Access Compliance Report

Public Rights-of-Way

(Curb Ramps)

Intersection ID: 20860	Main Street: CROWNPOINT_EXECUTIVE_DR	Cross Street: KREFELD_DR	Location: SW
ADA ID: 4202F4F101F8	Ramp Type: Perp	Initial Pass/Fail: Fail	Overall Compliance: No
Severity Score: 10			
Codes/Mitigation Info/Possible Solution		Field Measurements/Component Compliance

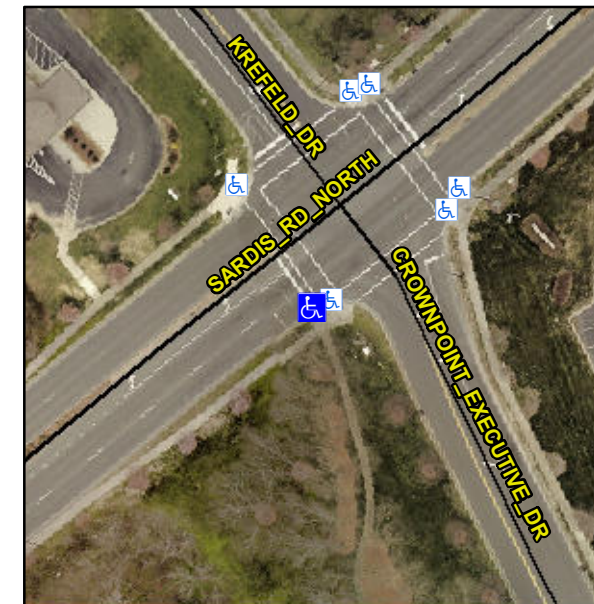
Not Found, R304.5.1

Compliance	Description	Data	Compliance	Description	Data
N/A	Ramp Length (in)	64.0	Yes	Ramp Slope (%)	7.1
No	Ramp Width (in)	46.0	Yes	Ramp XSlope (%)	2.1
N/A	Flare Type LT	N/A	N/A	Flare Type RT	N/A
N/A	Flare Slope LT (%)	N/A	N/A	Flare Slope RT (%)	N/A
N/A	Flare Traversable LT?	N/A	N/A	Flare Traversable RT?	N/A
N/A	Landing Length (in)	N/A	N/A	DWS Provided?	N/A
N/A	Landing Width (in)	N/A	N/A	DWS Contrast?	N/A
N/A	Landing Slope (%)	N/A	N/A	DWS Length (in)	N/A
N/A	Landing X Slope (%)	N/A	N/A	DWS Full Width?	N/A
N/A	Landing Curb? (Y/N)	N/A	N/A	DWS Offset (in)	N/A
N/A	Shared Landing?	N/A			
N/A	Gutter Ponding?	N/A	N/A	Gutter Slope (%)	N/A
N/A	Gutter Lip Ht (in)	N/A	N/A	Gutter X Slope (%)	N/A
N/A	Painted X Walk1?	No	N/A	Painted X Walk2?	N/A
	X Walk 1 Direction	To NW		X Walk 2 Direction	N/A
N/A	X Walk 1 Width (in)	N/A	N/A	X Walk 2 Width (in)	N/A
	X Walk 1 Slope (%)	0.8		X Walk 2 Slope (%)	N/A
	X Walk 1 X Slope (%)	2.7		X Walk 2 X Slope (%)	N/A

Remove & Replace Entire Ramp.
